ALAMEDA COUNTY
HEALTH CARE SERVICES

July 27, 2007

Subject: Fuel Leak Case RO0000206, Chevron Station 9-5542, 7007 San Ramon Rd.,
Dublin, CA 94568

Alameda County Environmental Health (ACEH) staff has reviewed the files for the subject site including the January 22, 2007 Subsurface Investigation Report by Cambria (CRA). The report describes the approved March 2, 2006 work plan by Cambria, namely the installation of MW-11, the attempted recovery of MW-5 and proposes remediation of MW-4. During this work, MW-11 was unable to be sampled and MW-5, although located, was not able to be rehabilitated. Recent e mail from your consultant states that they are going to proceed with the addition of oxygen into MW-4 as an attempt to remediate dissolved contaminants. Our office requests you address the following technical comments and submit the reports requested below.

REVISED SITE PLAN
 CHEVRON STATION #9-5542
 7007 SAN RAMON ROAD
 DUBLIN, CALIF.

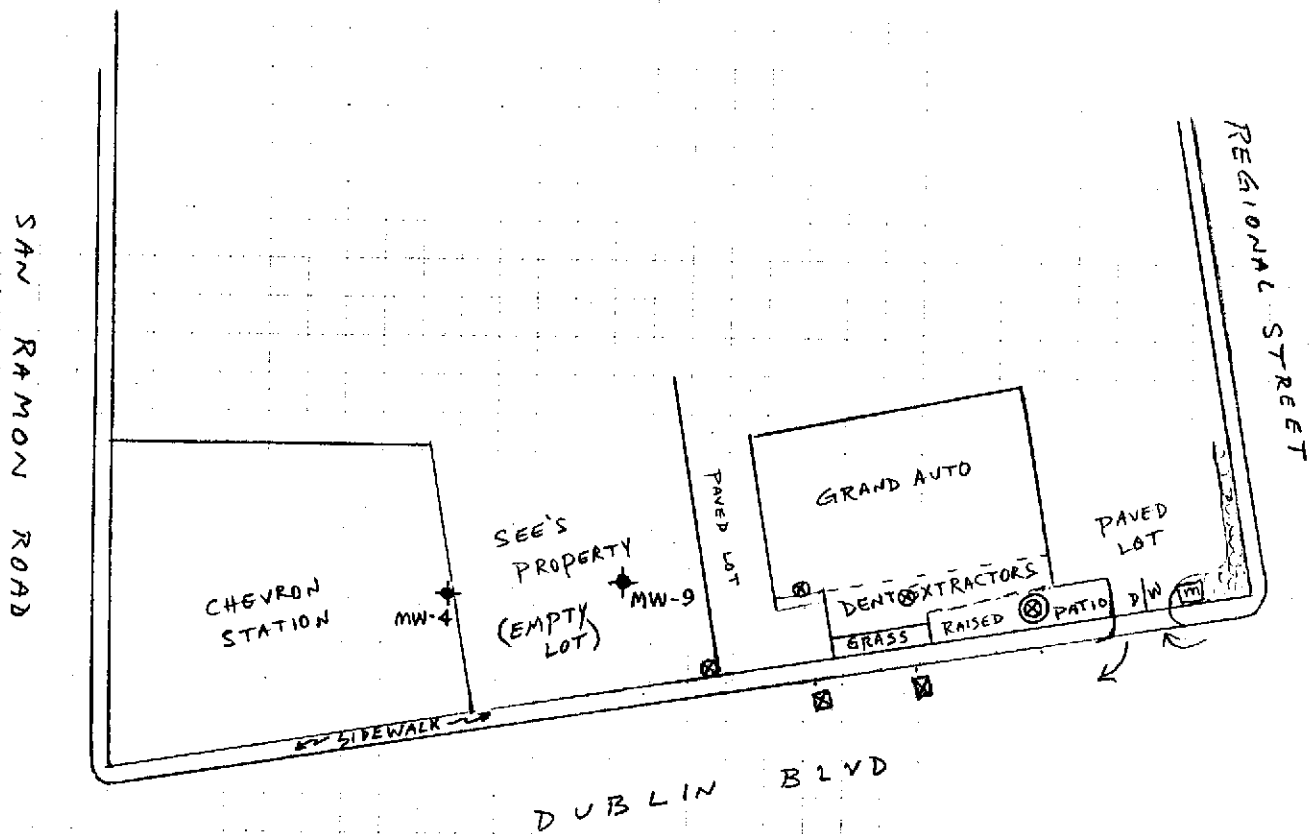
Attached is the Revised Site Plan for Chevron Service Station #9-5542, located at 7007 San Ramon Road, Dublin, CA. Proposed locations for the two eastern-most Geoprobe borings and monitoring well MW-10 must be moved due to the presence of Dent Extractors and Grand Auto Parts buildings. A heavy concentration of underground utilities beneath the sidewalk in this area requires the two Geoprobe borings be drilled in the curb lane of westbound Dublin Blvd. The location of the third Geoprobe boring, in the vacant lot east of Chevron, will remain unchanged. The proposed location of monitoring well MW-10 must be moved due to the presence of a fenced, raised patio bordering the sidewalk and has not been finalized yet.

FIGURE
 1
JOB No
 1196

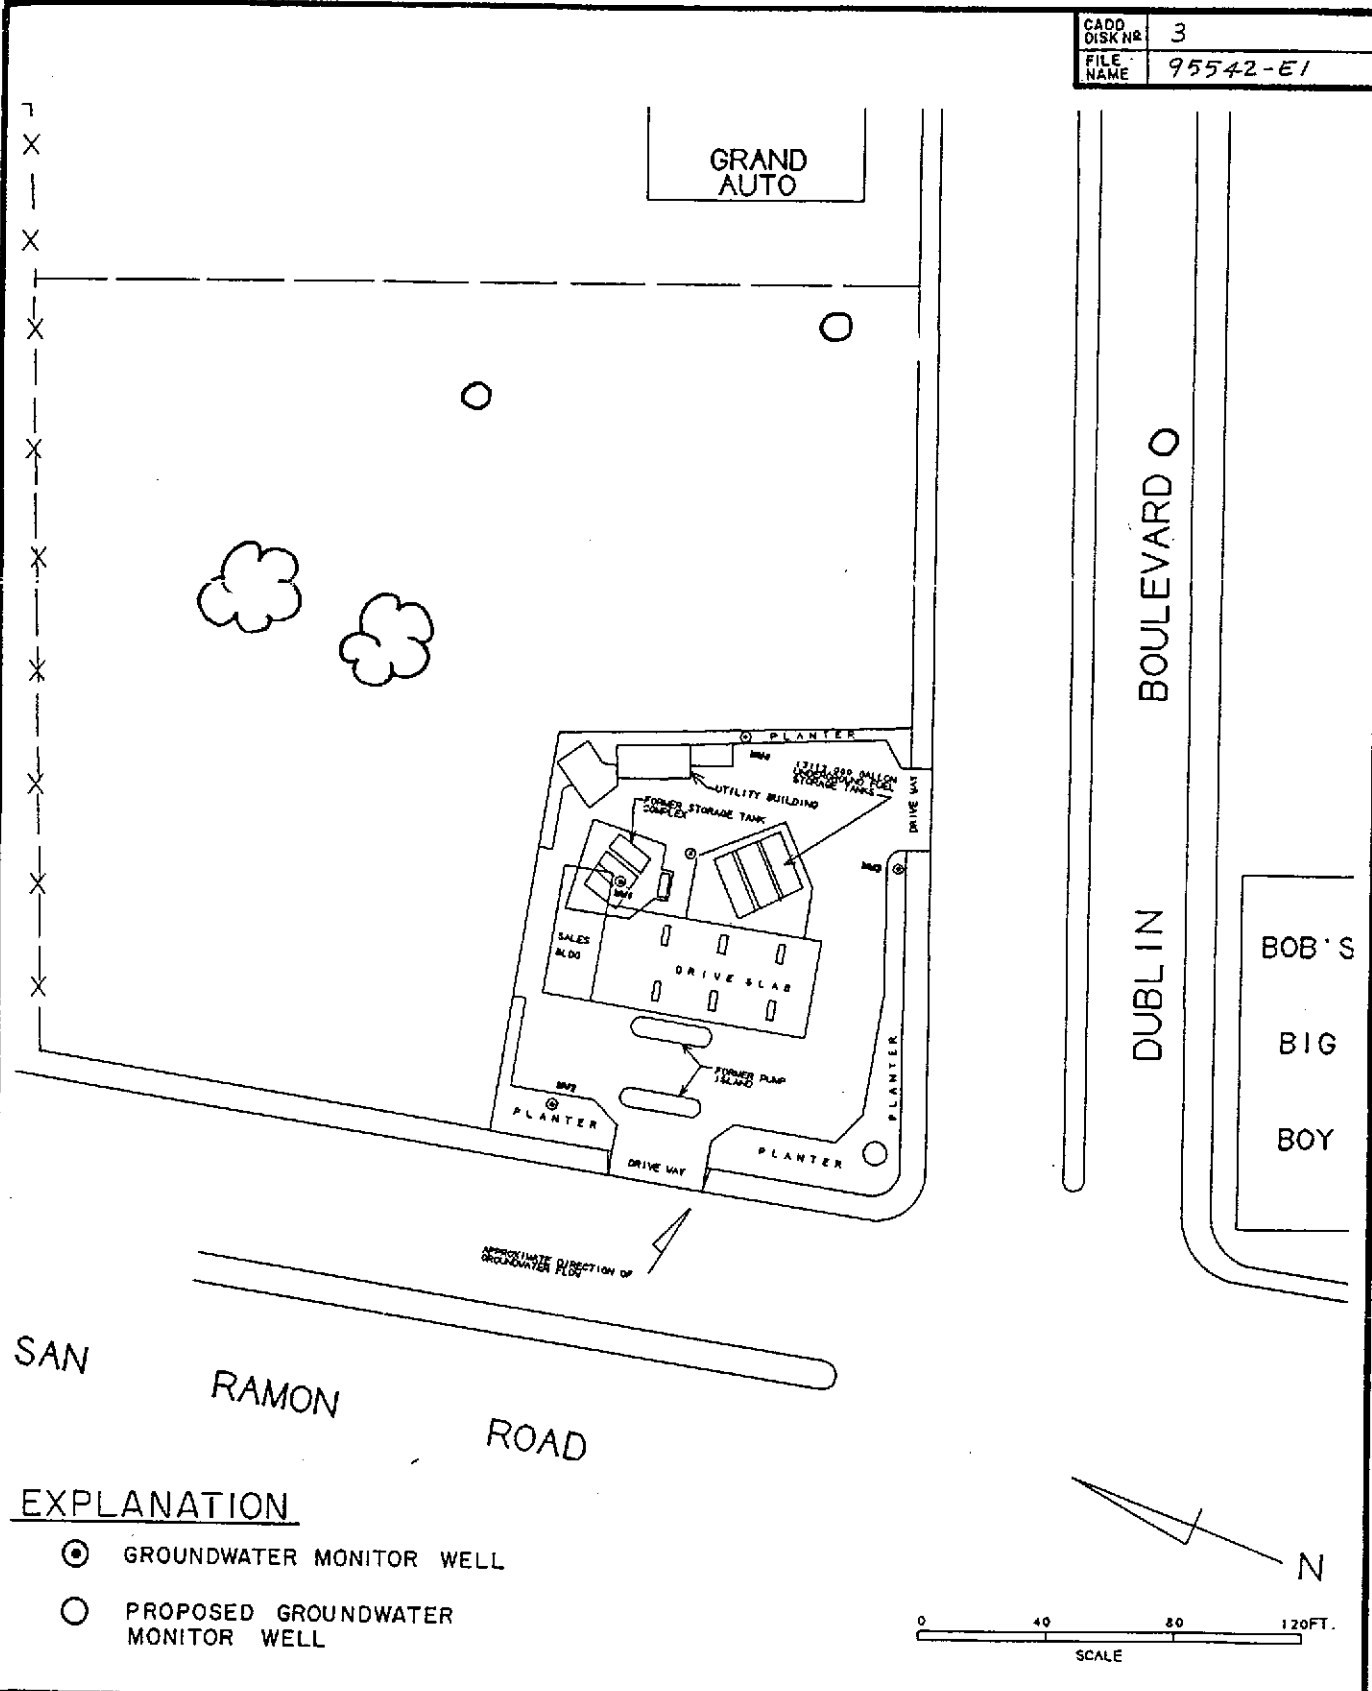
I have also enclosed a copy of the proposed well locations for your review. As indicated on the map, installing the wells beyond See's Candies property could possibly provide us false plume definition.
